S T E W A R T

RECOMMENDATION MEETING

800 Stewart St, Seattle, WA

SDCI#3034006-EG

8TH AVE ENTRIES

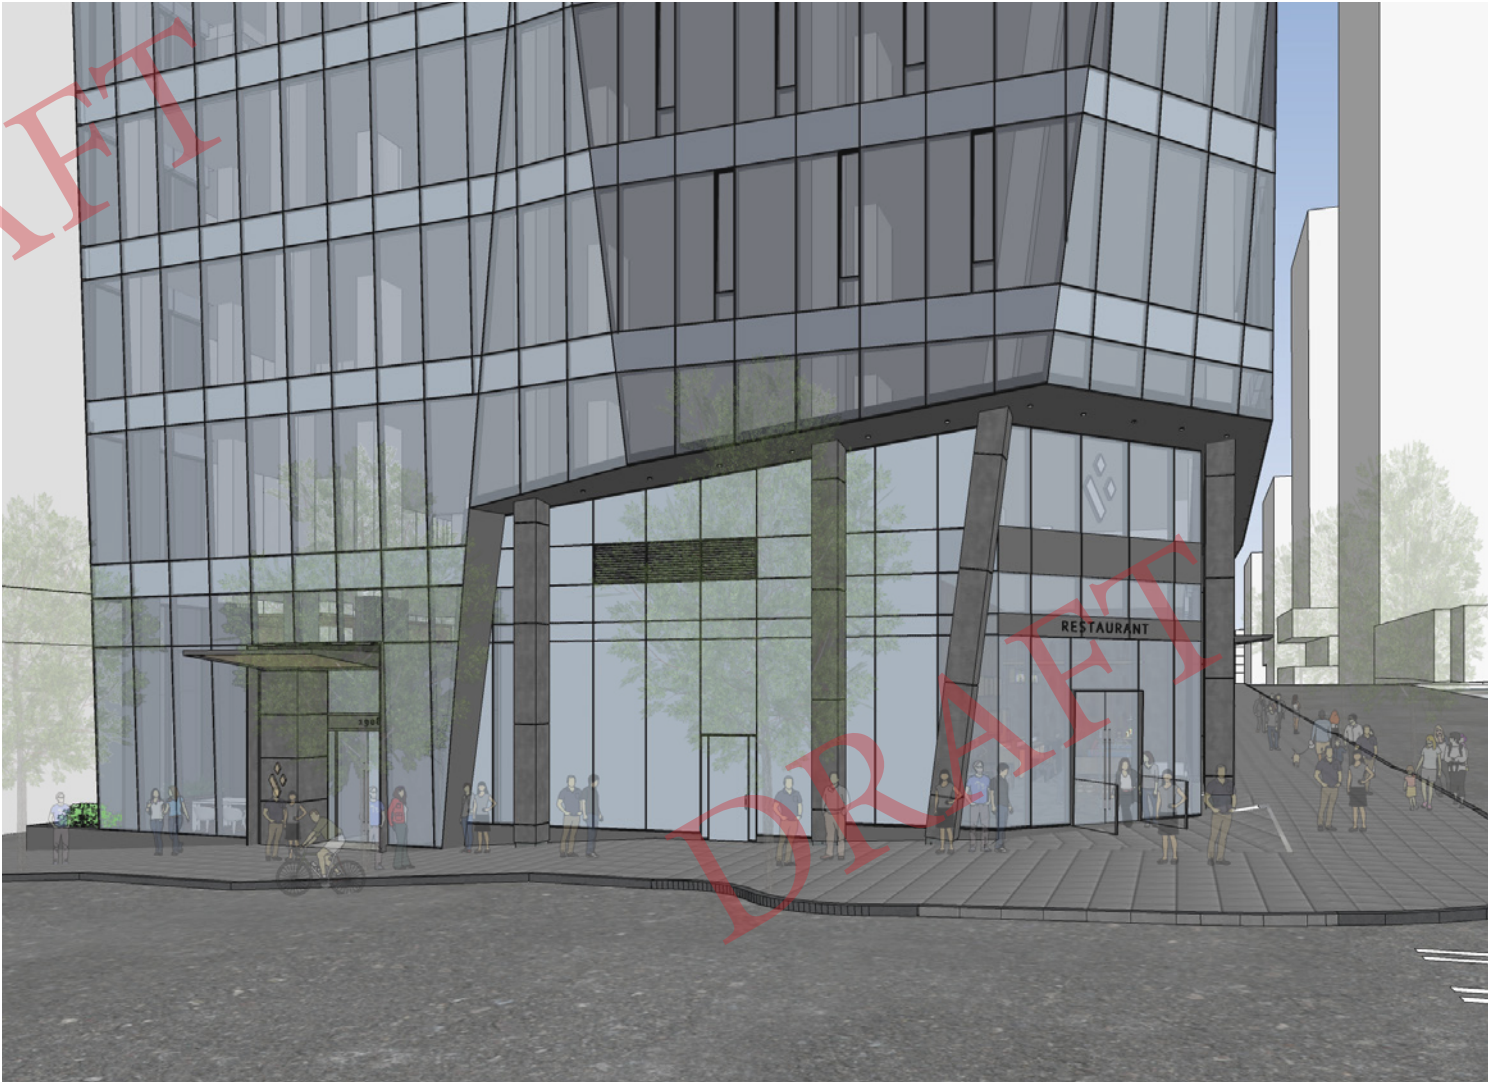
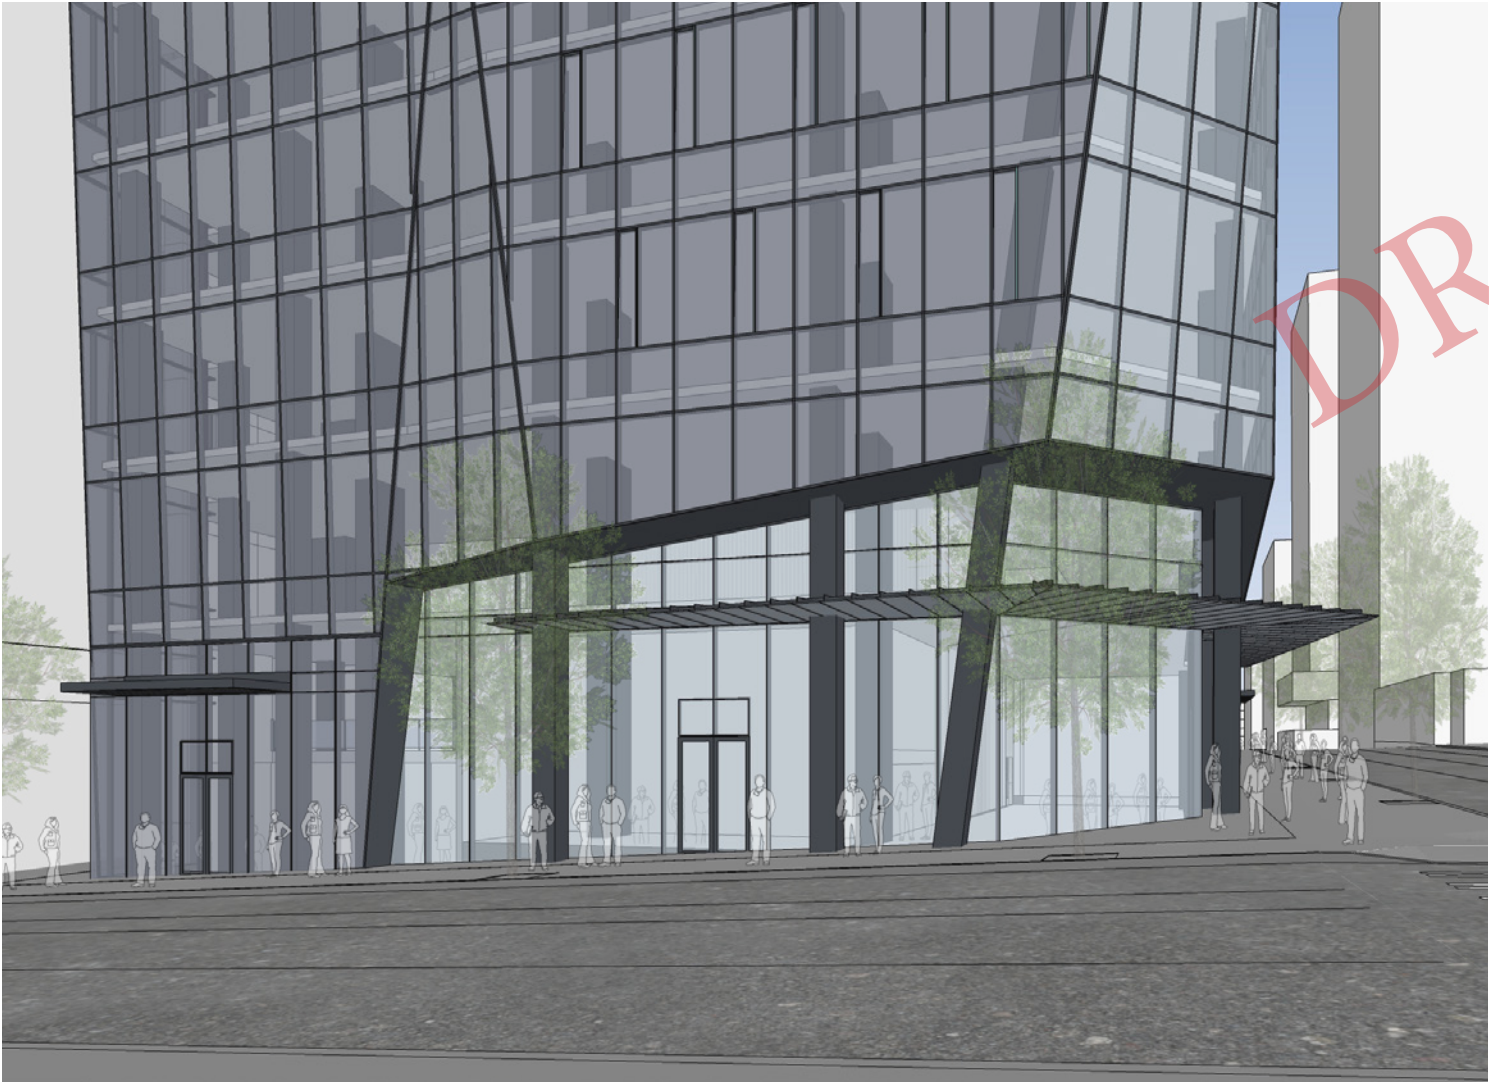
4 a.a. The Board agreed that the programming and expression of building entries would require further exploration. In particular the Board requested further study of the corner and the regular, rectangular entry recesses relative to the refracted geometry of the tower above. (D-3, C-1, C-2)

The Board provided additional guidance that the arrangement and expression of the overhead weather protection should also be included in this exploration and that the result should be a unified and coherent expression at the pedestrian level.
(B-4, C-4, C-1)

The design team has taken several steps to enhance the building entrances. Most significantly we moved the primary corner retail entry to the corner portion of the storefront. This was a verbal recommendation for study in the EDG 2 meeting and allows the corner retail entrance to be housed within the strong architectural expression created by the angled “wishbone” columns and punched in portion of the storefront glazing. The entrance provides a focal point for this bold architectural statement. Additionally, the design team has refined the other building entrances to each be of a similar language but contain a specific character that is unique to their programmatic use. The office entrance portal has been integrated with the overhead canopy and detail so that it appears to “float” within the portal. A clean lighting scheme and detailing reflect the commercial use of this entrance. Likewise, the residential entrance is utilizing a portal with integrated floating canopy however the design has integrated a large blackened steel pilaster. This pilaster grounds the entrance, provides a more residential feeling for the entrance, and provides an opportunity for prominent residential signage. These moves strengthen the architectural expression of the project at grade, provide a unique yet unified entrance condition for the various programmatic uses, and enhance wayfinding.

The residential entrance is utilizing a portal with integrated floating canopy however the design has integrated a large blackened steel pilaster. This pilaster grounds the entrance, provides a more residential feeling for the entrance, and provides an opportunity for prominent residential signage.

PREFERRED DESIGN - A

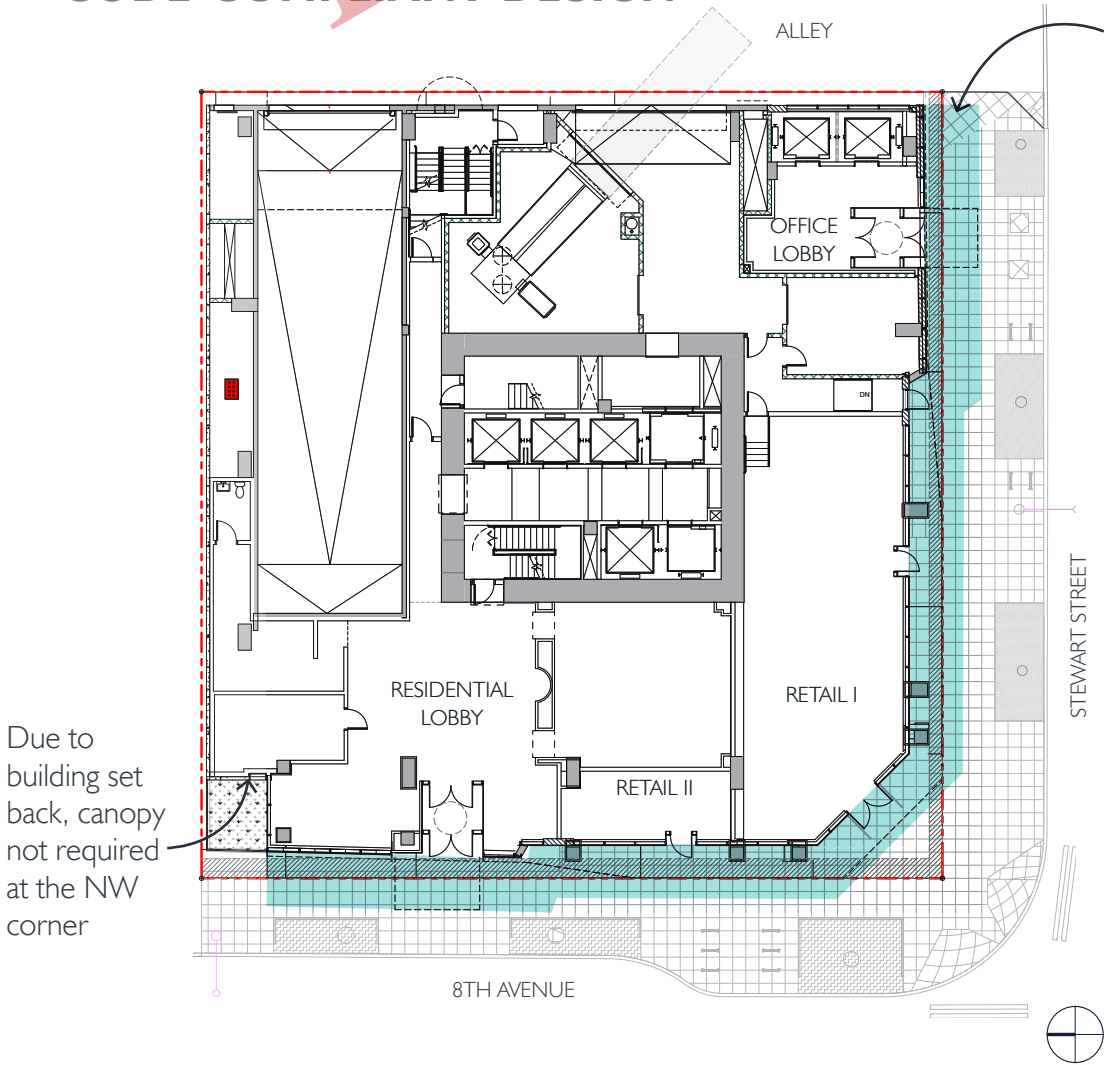
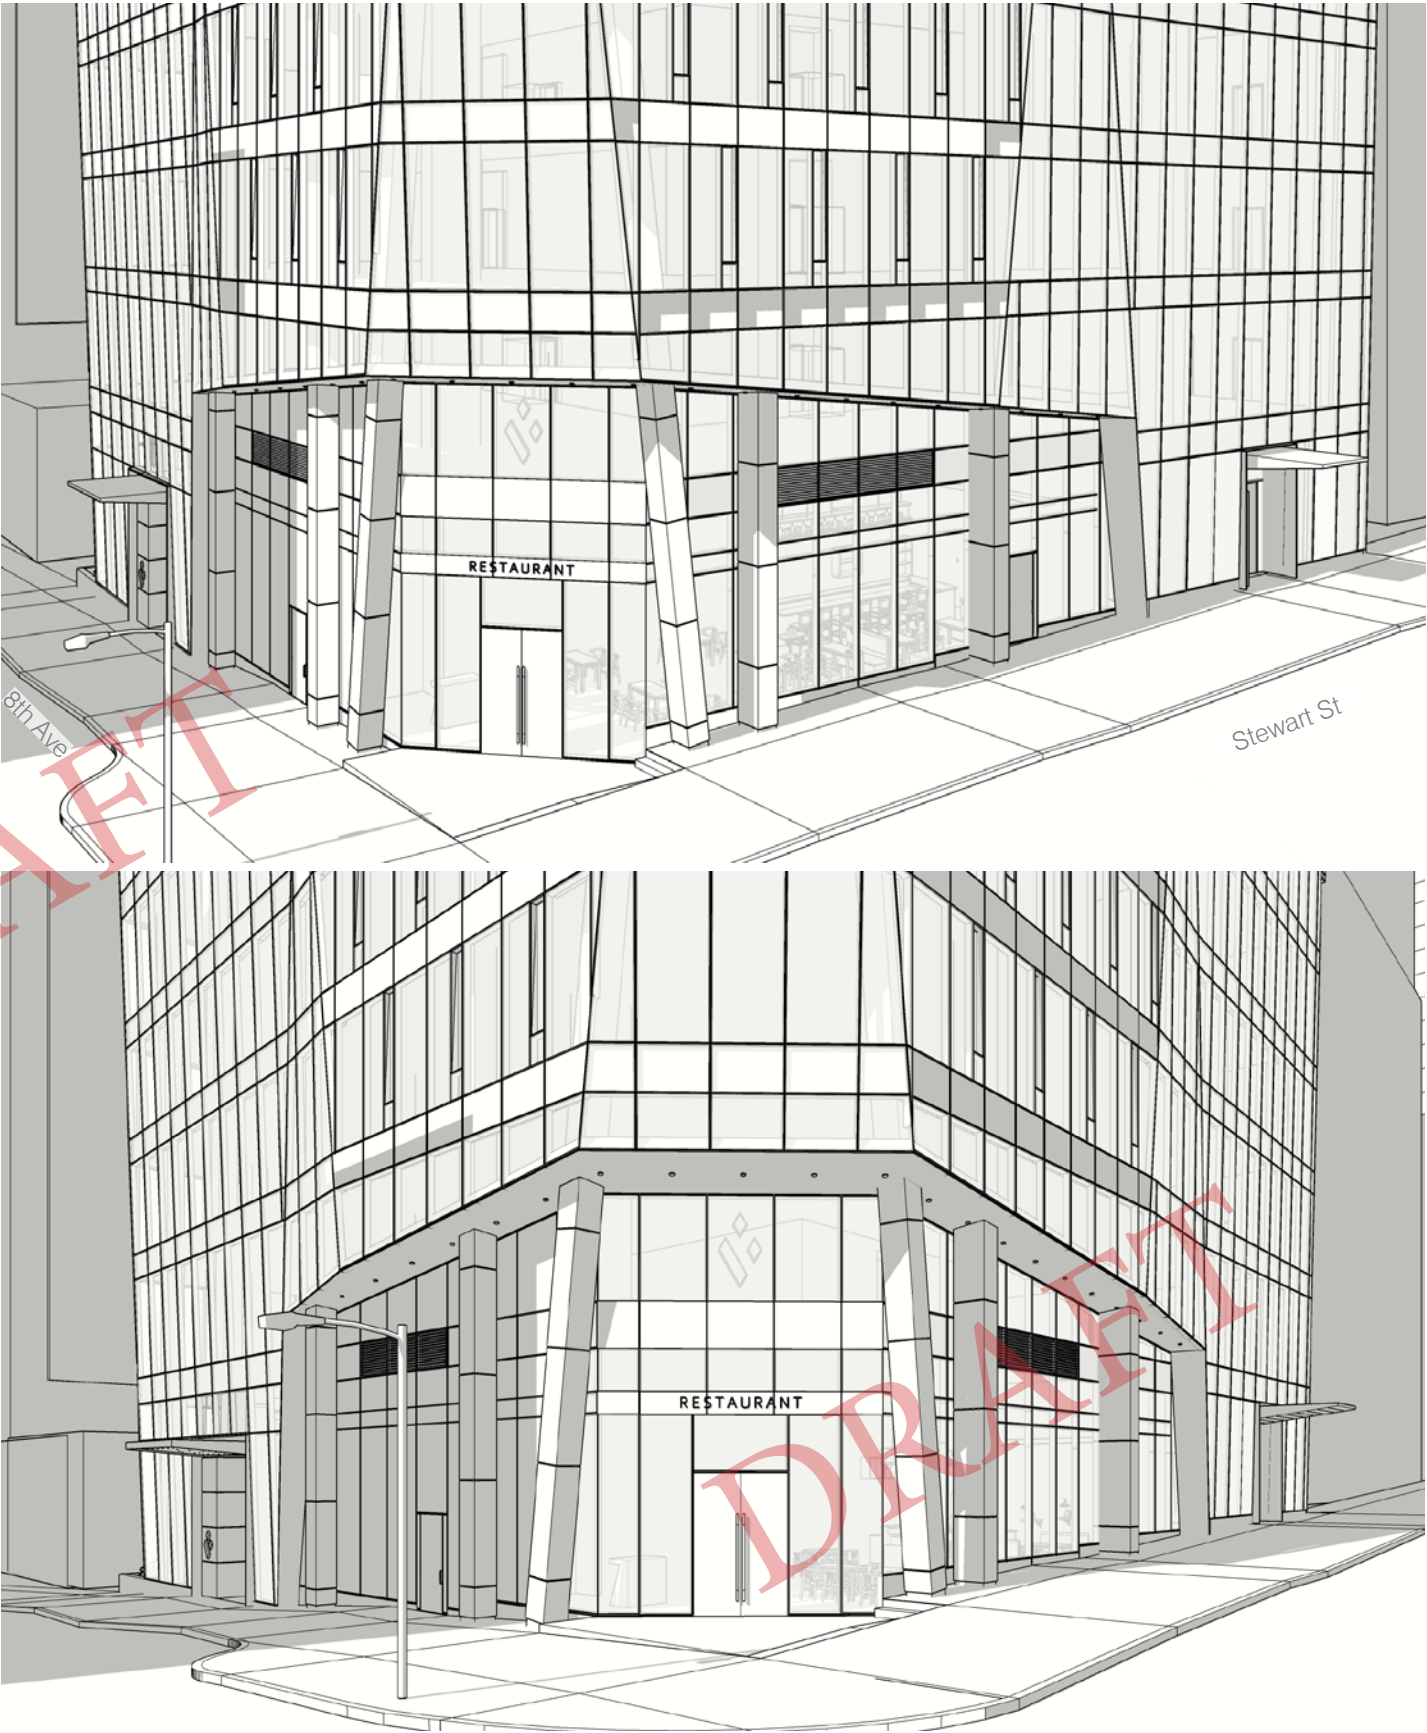
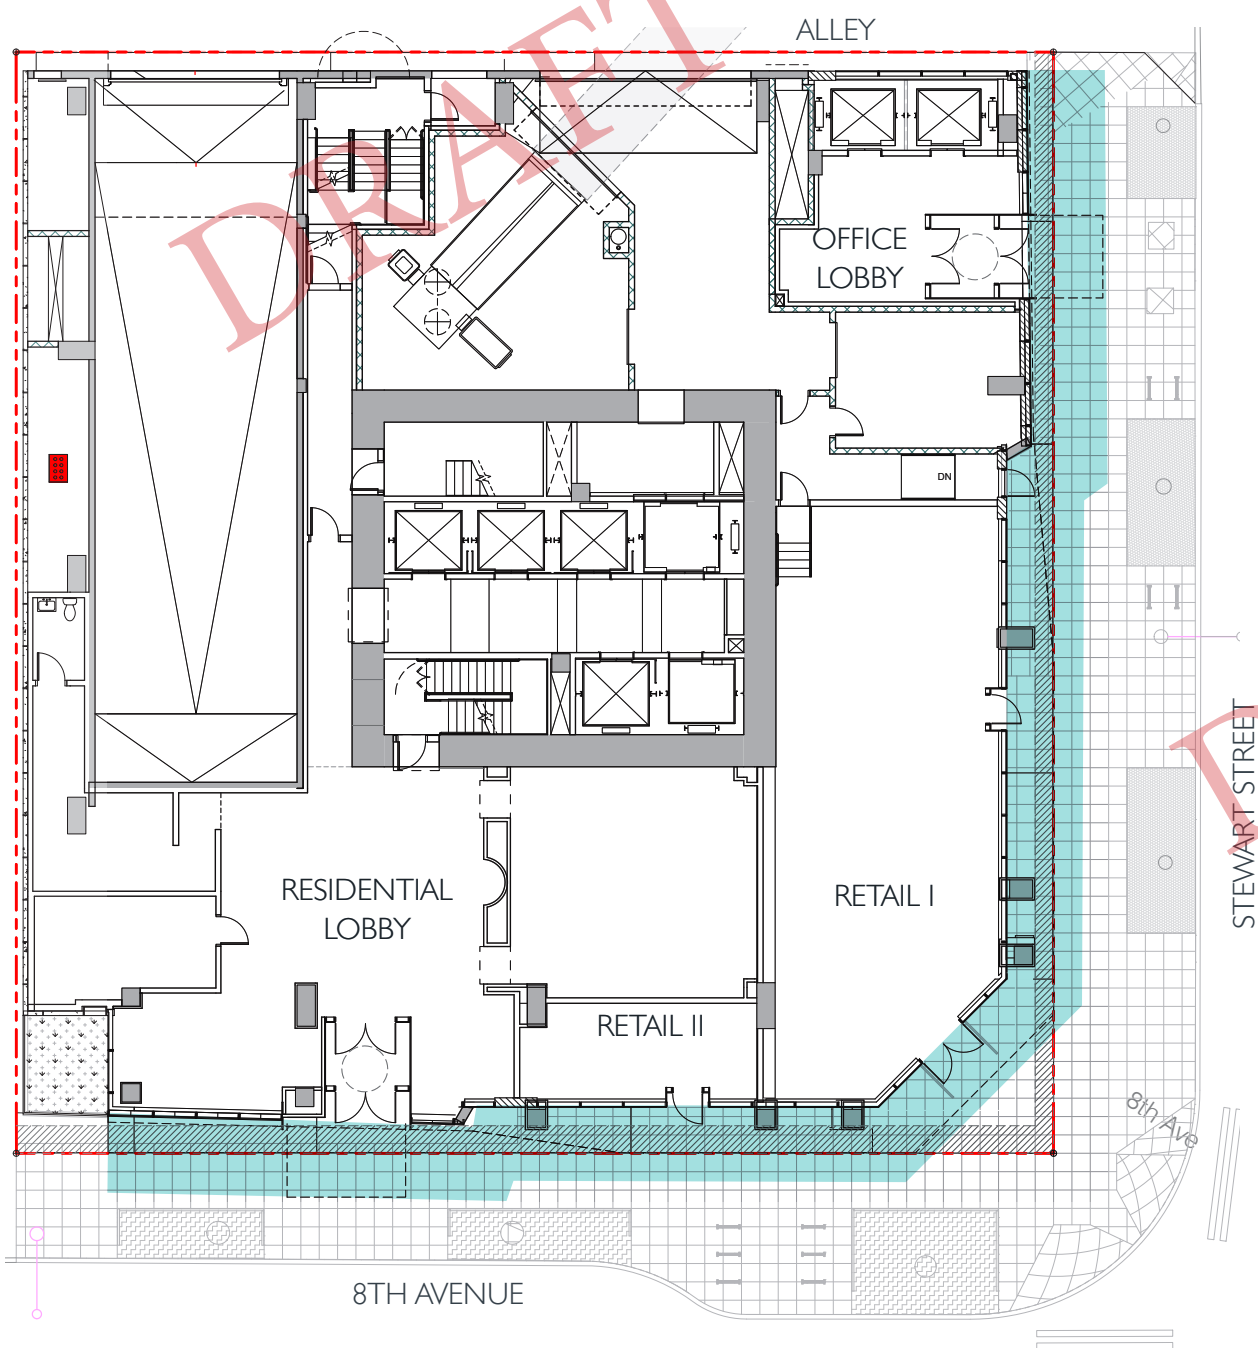
Overhead weather protection shall have a minimum dimension of eight feet measured horizontally from the building wall...

The project is proposing areas of overhead weather protection of varying depths that are less than 8 feet measuring horizontally from the building wall. One portion along 8th Ave that is 19'-6" and 54'-10" in length. A portion along Stewart St that is 15'-9" and 77'-6" in length. The corner of 8th and Stewart at 26'-4 3/4" in length.

The board has encouraged the design team to explore bringing a portion of the tower down to grade, as well as further differentiating the building entrances. As a result the design team has created a plane change between the major building uses and entrances at the ground floor, allowing a portion of the tower to meet the ground and further distinguishing the uses of different building entrances. Separating the canopies provides distinction between building entrances while also more closely adhering to the design parti of two "shoulders" of the tower that meet the ground with an elevated and setback corner retail expression.
